APPLICATION NO:
F/2000/0654

PROPOSAL:
Proposed single storey rear extension to dwelling to form conservatory.

Notification of Approval of Permission

WORK SHEET FOR : ~~Natalie Brown~~ Andrew Thorley

Rear Elevation

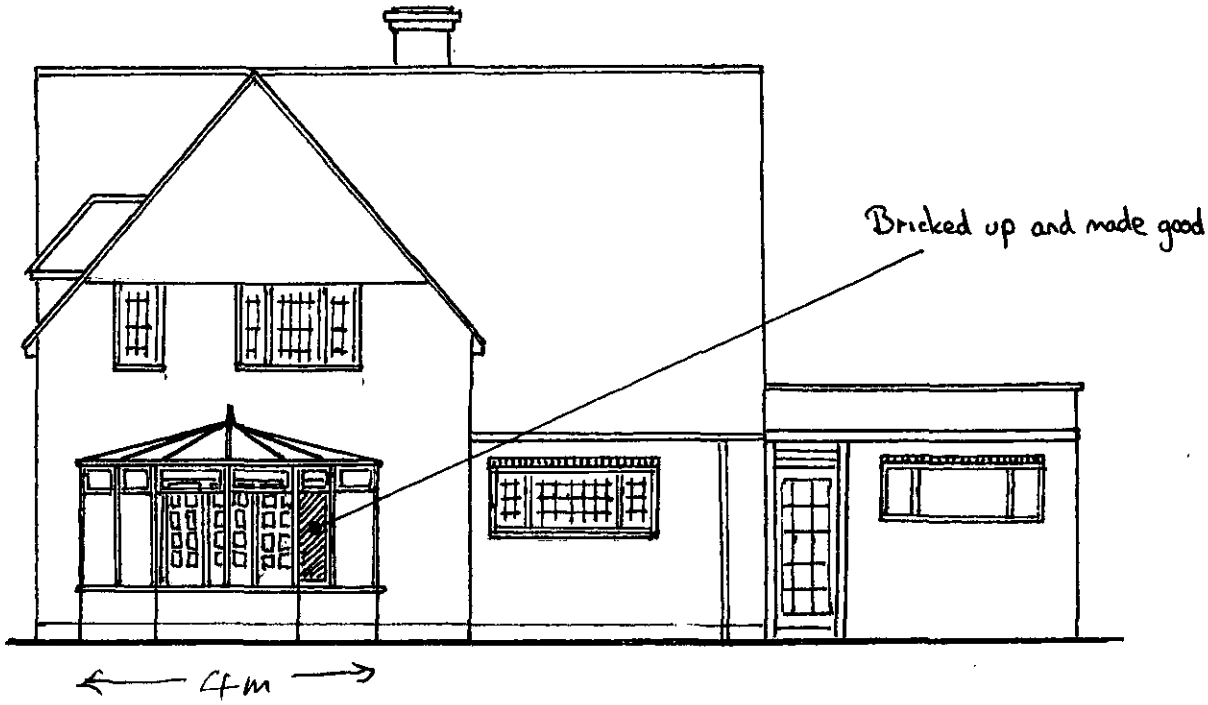
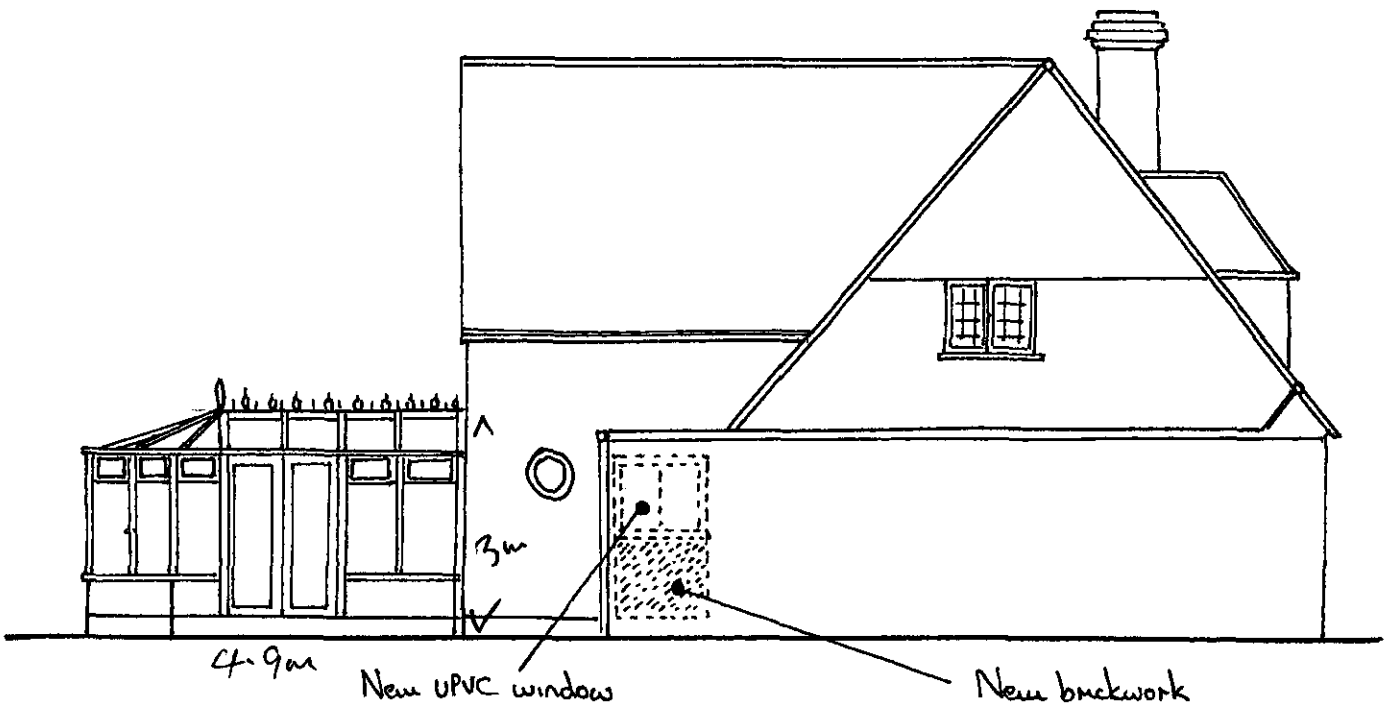
The proposal involves the addition of a conservatory measuring 4m wide, 4.9m long and 3m to ridge, on the rear elevation, considered acceptable — no impact on streetscene / visual amenity of area.

GROUND FLOOR PLAN

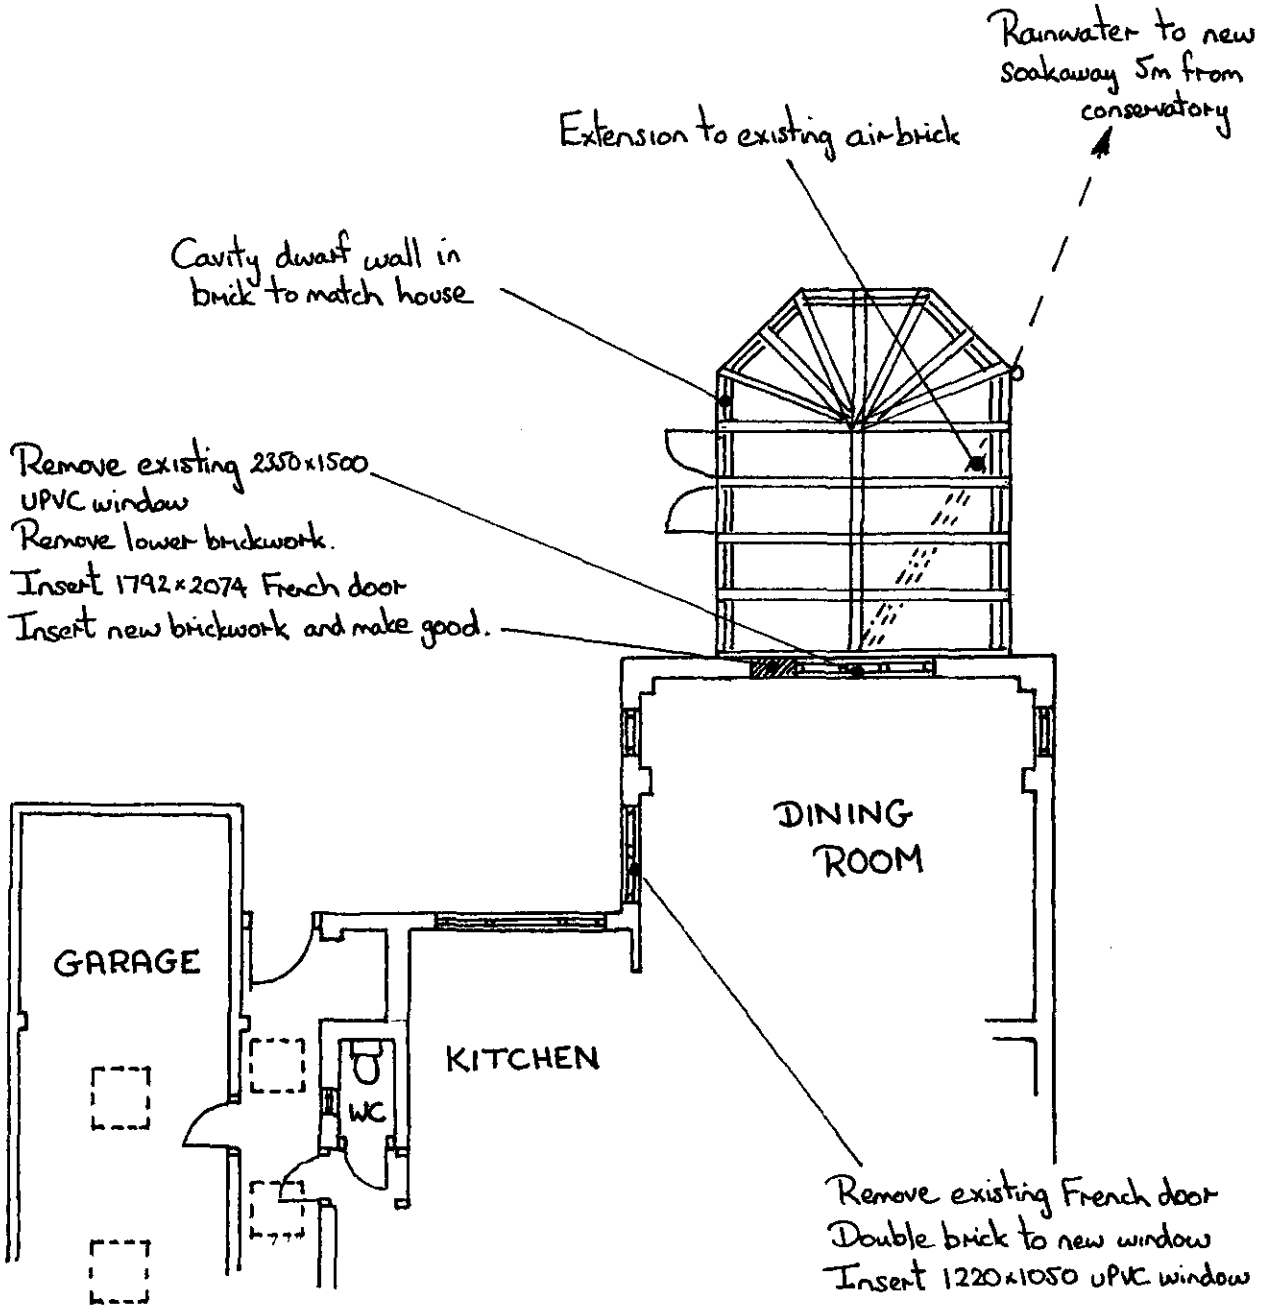
I have examined the site plan and ground floor plan provided and confirm that in principle there are no objections to the proposals at this time.

I have examined the site plan and ground floor plan provided and confirm that in principle there are no objections to the proposals at this time.
